**From:** Comar, Manny  
**Sent:** Thursday, November 01, 2012 5:05 PM  
**To:** TurkeyCOL Resource  
**Subject:** FW: DRAFT RAI Responses FPL Turkey Point 6 & 7 for eRAIs 6006 & 6184 Stability of Subsurface Materials and Foundations  
**Attachments:** Draft Revised Response for NRC RAI Letter No. 040, RAI 02.05.04-1 (eRAI 6006).pdf; Draft Revised Response for NRC RAI Letter No. 040, RAI 02.05.04-25 (eRAI 6184).pdf

**NRC RAI Letter No. PTN-RAI-LTR-040**

**SRP Section: 02.05.04 - Stability of Subsurface Materials and Foundations**

**NRC RAI Number: 02.05.04-1 (eRAI 6006)**

Figure 1. Line 10 Geophysical Data

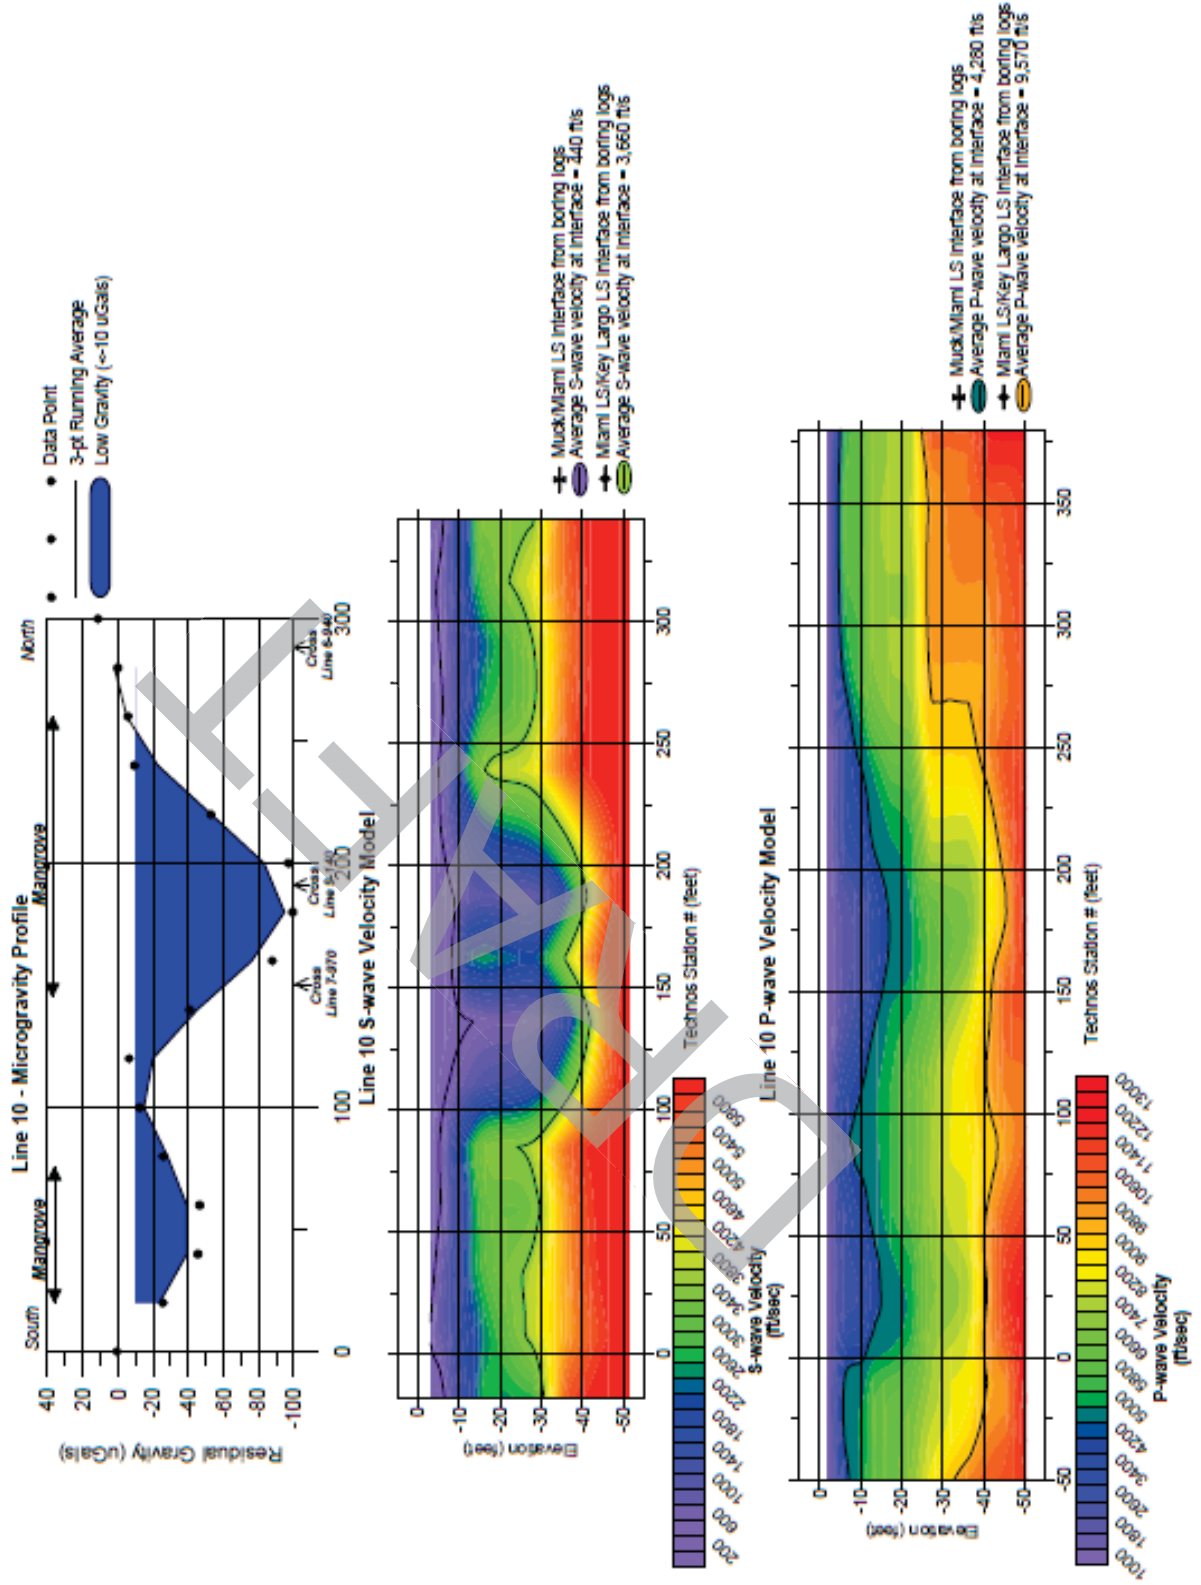
FSAR Section 2.5.4.1.2.1 presents a discussion on dissolution activity in the limestone formation, including potential cavities at depths. Among the data sets used to assess the potential existence of cavities is the microgravity data presented in Figures 2.5.4-224 through 231 which provide insights into the existence of potential cavities in at the site. Based on the analysis of gravity data analyses, this section concludes that there are no large cavities underneath the site. In accordance with NUREG-0800, Standard Review Plan, Chapter 2.5.4, "Stability of Subsurface Materials and Foundations," and Regulatory Guide (RG) 1.132, "Site Investigations for Foundations of Nuclear Power Plants" please provide additional discussion on the adequacy of the assumptions used in the microgravity data analyses. Since only profile measurements were made and large gaps remain between profiles throughout the site area, please justify your assumption that no large cavities exist throughout the site. Also, please provide additional references and data sources used to reach this conclusion.

FPL has reached its conclusions that the likelihood for encountering extensive dissolution beneath the power block is small based on the integration of geological/geotechnical data collected during the subsurface investigation program as well as the use of three concurrent geophysical surveys (microgravity, seismic refraction, and multi-channel analysis of surface waves). The seismic refraction and multi-channel analysis of surface waves (MASW) data are helpful in removing the effects of the overlying less dense muck in the interpretation of the microgravity survey data. As shown in FSAR Figure 2.5.4-227 and Figure 1, the MASW survey data also indicate that the muck is thicker above surficial solution features (vegetated depressions) that appear to be floored by continuous Key Largo limestone.

The assumptions used in the microgravity data analysis include assuming that a spherical, water-filled cavity would have a sufficient density contrast with the surrounding limestone to produce a microgravity anomaly. The density contrast is based on laboratory test and published data summarized in the FSAR Subsection 2.5.4.4.5.4 and on experience conducting similar geophysical surveys in south Florida. A spherical cavity was used in the analysis as the most conservative approach since it represents the most compact form of "missing mass," and therefore produces the smallest gravity anomaly for a given cavity diameter. Other geometric distributions of a cavity, having the same diameter as the sphere, would produce a significantly larger gravity anomaly. The detectability of the anomaly varies with cavity size, depth, and location with respect to the survey line.

To further reduce any uncertainties in the resolution and interpretation of microgravity data with depth, and away from geophysical survey lines and boreholes, FPL proposes a commitment to conduct a microgravity survey on the base of the nuclear island (NI) excavation. The current excavation concept is to grout the excavation as part of the dewatering program. FSAR Subsection 2.5.4.5.4 describes the dewatering and excavation methods. The installation of a grout plug, approximately 25 feet thick, to prevent vertical seepage is described in FSAR Subsection 2.5.4.6.2 and, in more detail, in ER Subsection 3.9.1.7. The grout plug will be constructed from elevation -35 feet NAVD 88 to elevation -60 feet NAVD 88 by first drilling from the ground surface and then grouting. Vertical boreholes will be drilled in a grid pattern and grouted in an iterative process, which is estimated to consist of four rounds of drilling and grouting, prior to excavation. The grouting procedure described in ER Subsection 3.9.1.7 is expected to fill voids that may exist beneath the nuclear island excavation to an elevation of -60 feet NAVD 88. It is anticipated that the density of the grout will be similar to that of the foundation limestone and that the proposed microgravity survey will be designed to detect density anomalies below the grout plug that represent potential solution features with a diameter of 25 feet or greater if spherical and 12 feet or greater if cylindrical. Preliminary estimates indicate that a hypothetical solution feature with an approximate diameter of 30 feet at a depth immediately below El. -60 feet NAVD 88 will have a negligible effect on the stability of the nuclear island foundation, i.e., negligible effect on bearing capacity, settlement, or resistance to sliding. Such a cavity would cause an increase in stress levels in the vicinity of the cavity due to stress redistribution. However, the stresses from the design loading on the nuclear island at that depth are comparatively low (less than 50 psi) so that the effects are insignificant in the limestone of the Fort Thompson Formation with an average unconfined compressive strength of 2,000 psi (FSAR Table 2.5.4-209).
